# Final Environmental Impact Report

## 557 East Bayshore Road Project

December 2022

*Spartina foliosa* in the muted tidal channel. Bay Trail is on the right. (9/2022 M. Leddy)

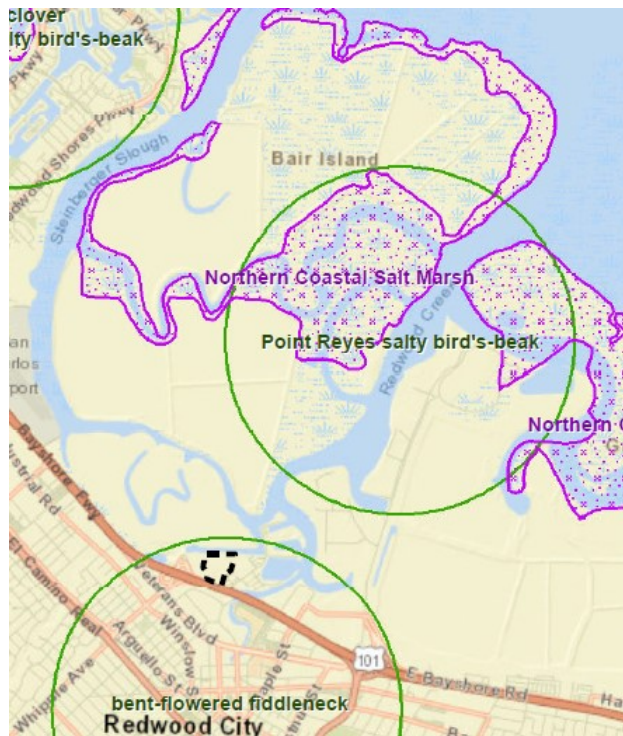
The recent photo below shows the great extent of *Spartina foliosa* in the muted tidal channel.

The DEIR should provide an accurate description of this adjacent CWA jurisdictional wetland that could be directly impacted from construction, grading and landscaping activities associated with the Project.
